## SERVICE BULLETIN

### Old style Blade Hitch Arm interference on new 440

**Bulletin No:** JC-13-03

**Product Type:** Steiner BD Snow Blade Attachments

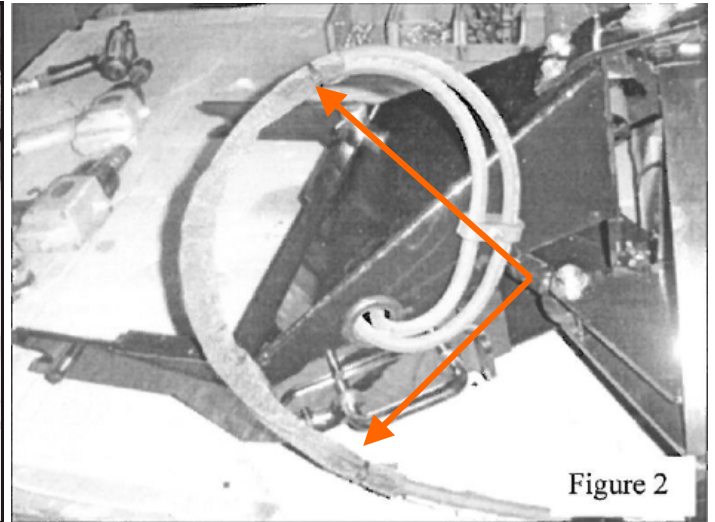
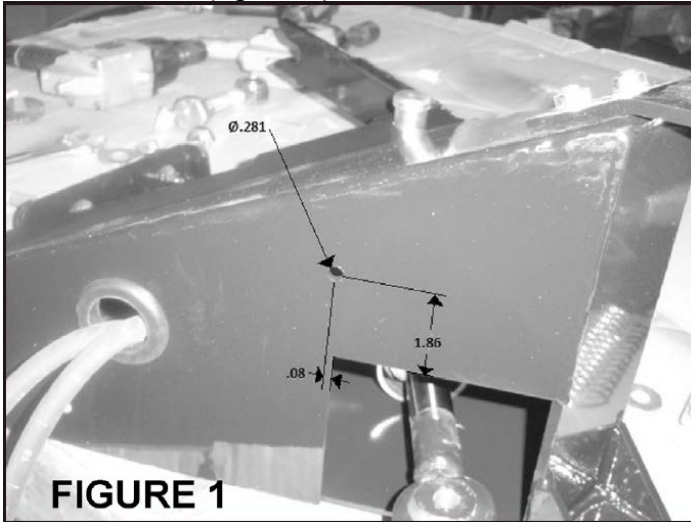
- A. Order kit **970439** and you will receive all the parts needed to upgrade
- B. Mark a center point on the right hand face of the blade attaching frame 1.86" above and .08" to the left of the square cut out. Ensure the hoses are not in danger of being hit with the drill bit. (figure 1)

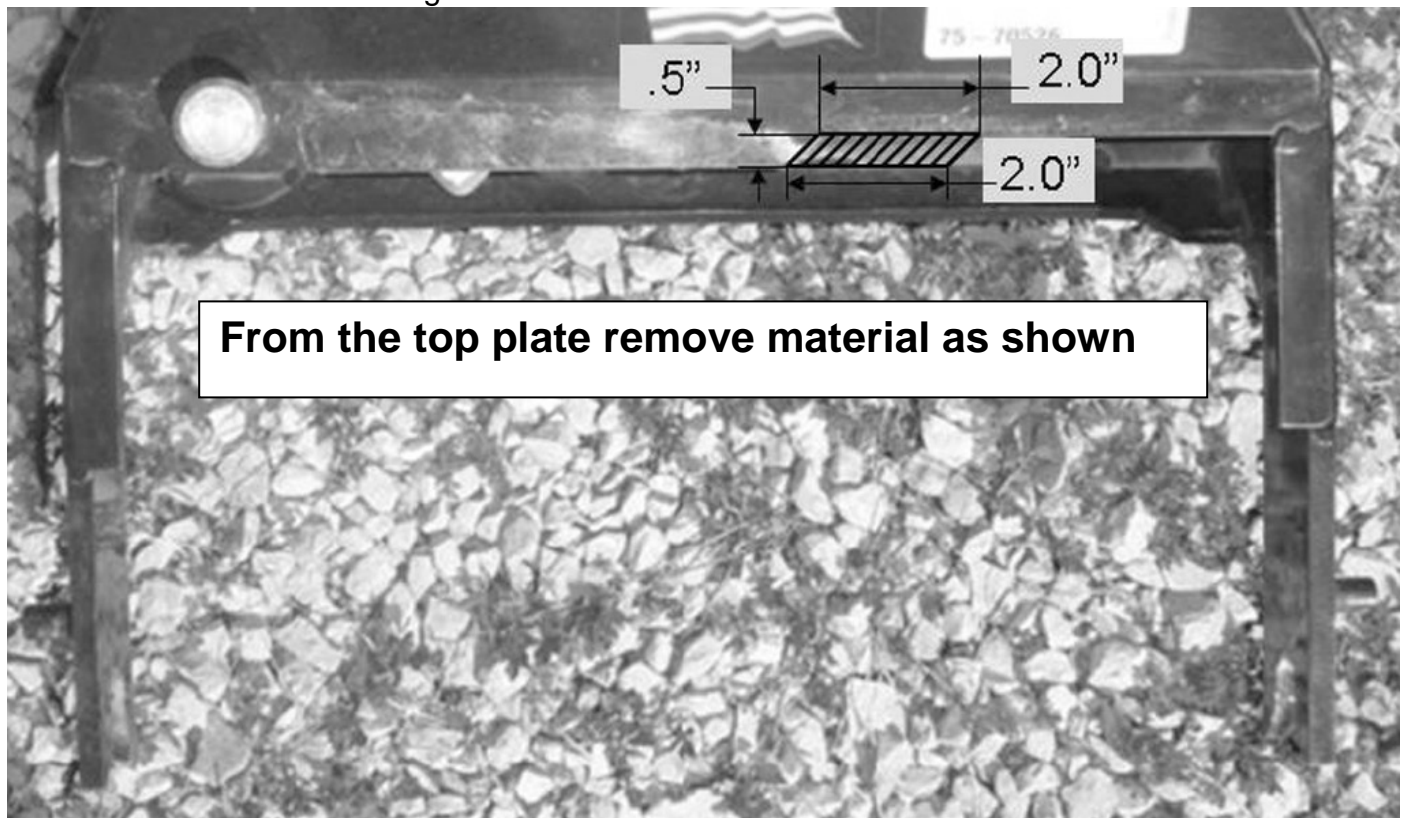
- C. Route the hoses through the clamp 4165751 and attach to frame through the hole drilled in previous step using the 64123-07 bolt and 64229-01 nylon lock nut.
- D. Slide the protective sheath 56-076-04 onto both hoses and zip tie, one each end.  
(figure 2)

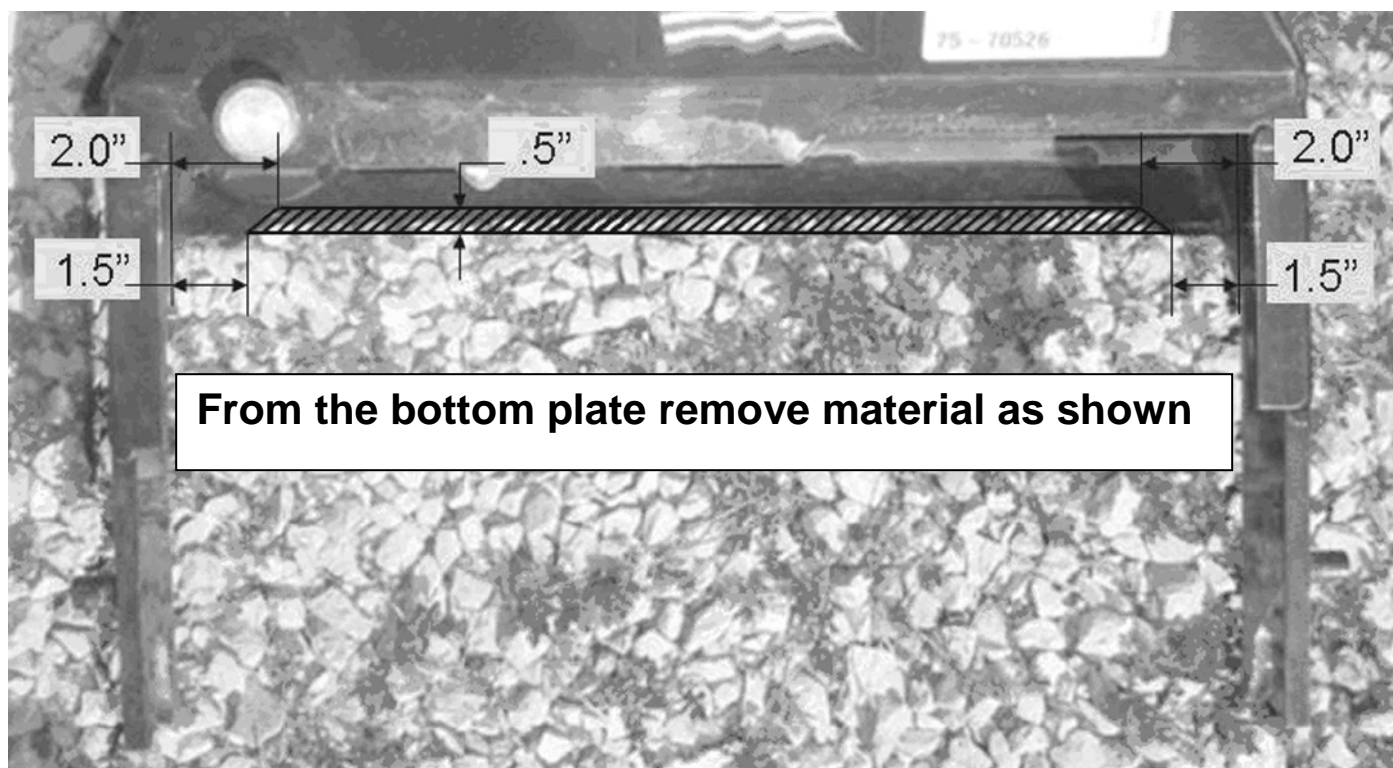
- E. Cut the attaching frame as shown.
